Version 2

Clunking or Looseness in the Outer Tie Rod

Supersedes 23-019, dated May 4, 2023, to revise the information highlighted in **yellow**.

**SAMPLE IMAGE OF
GOOD CLEAN SURFACE**

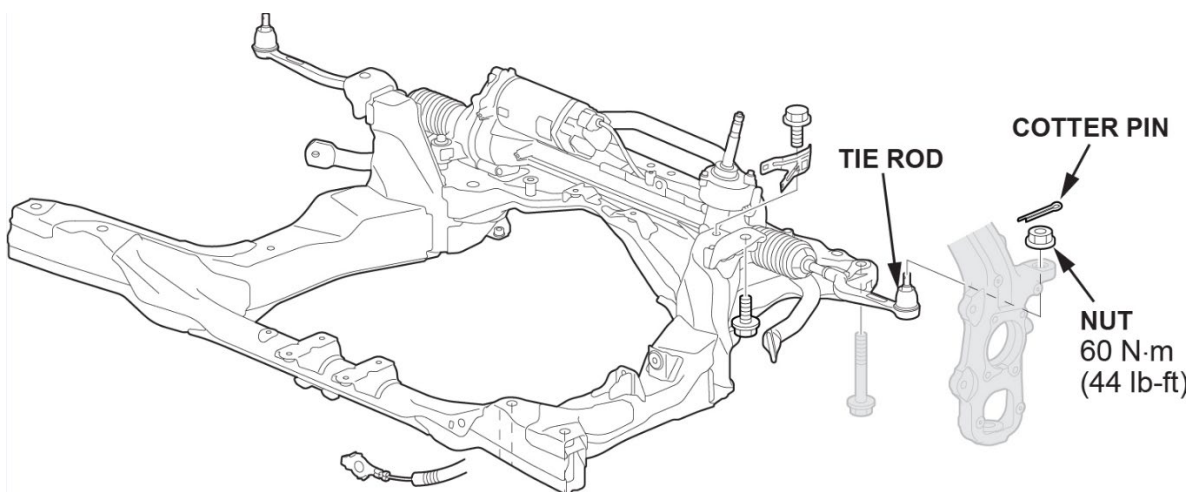
1. With the vehicle raised, remove the front wheel from the side that will need repair.
2. Remove the loose outer tie-rod cotter pin and nut.
3. Clean the mating surfaces with compressed air before reinstalling. Those surfaces should be smooth and free from any debris.

4. Install a new nut and cotter pin.
